OEB STAFF INTERROGATORY 1

IESO-EWT/LSL-Staff-1

**Ref: IESO's Addendum to the 2017 Updated Assessment for the Need for the East-West Tie Expansion; Reliability Impacts and the Projected System Costs of a Delay to the Project In-Service Date, dated June 29, 2018
Figure 1, Page 2**

Figure 1 Expected Incremental Northwest Capacity Requirement under Reference Demand (2017 Update Report)

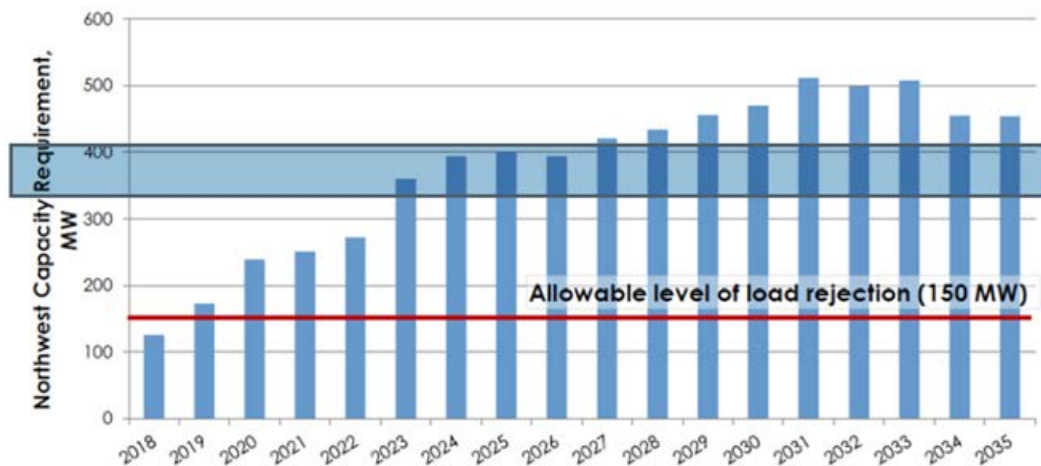
a) Has the IESO revised its peak demand forecast for the Northwest region since the last assessment update? If so, please provide an update to Figure 1.

Figure 2. Northwest Net Peak Demand Outlooks

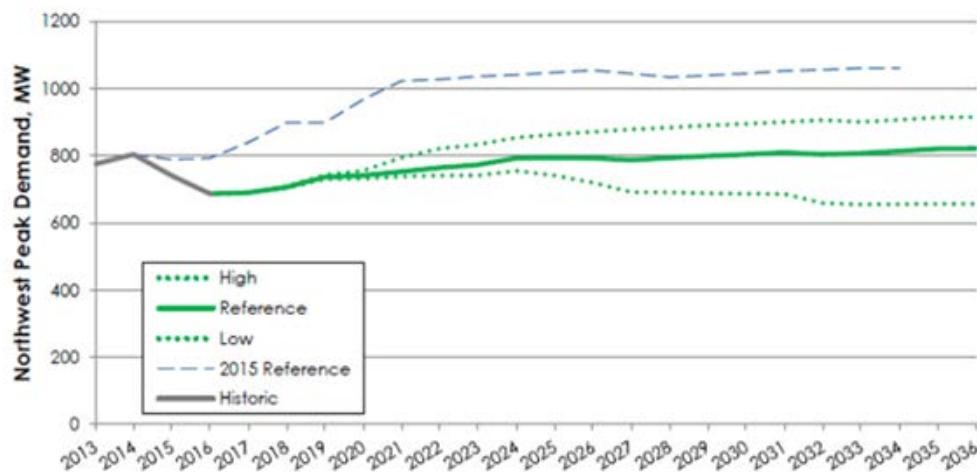
b) Forecast peak demand has declined materially since the 2015 Reference. Please provide evidence this trend has reversed since 2016, as per the Reference line in Figure 2.
